**BACK RIVER PROJECT**  
**Responses to 2021 Annual Report Comments**

**August 19, 2022**

An updated figure 4.5.9-1 is provided below.

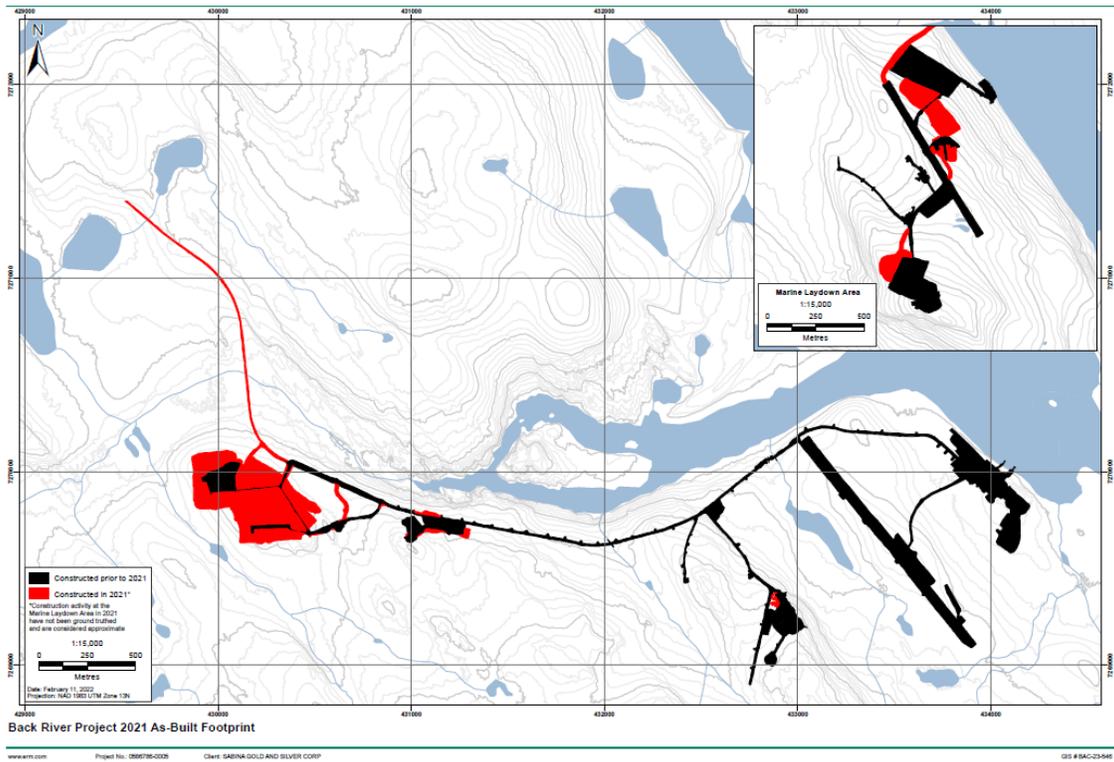
- Please present ecosystem/vegetation loss in 2021 compared to 2020, as specified in the 2020 VMP. Please update Table 4.5.9-1 and Figure 4.5.9-1 to show the quantitative and spatial data, respectively.
- Please explain why the ‘undifferentiated tundra’ vegetation association is missing from Table 4.5.9-1. Please also explain and correct the inconsistencies noted between Table 4.5.9-1 and habitat loss information within the Vegetation Monitoring Program and WMMP reports.
- Please complete a trend analysis for vegetation monitoring data from 2018 to 2021 or provide science-or statistics-based rationale for when trend analyses will be possible.

Please see the updated Table 4.5.9-1 showing the vegetation losses in 2021 as compared to 2020:
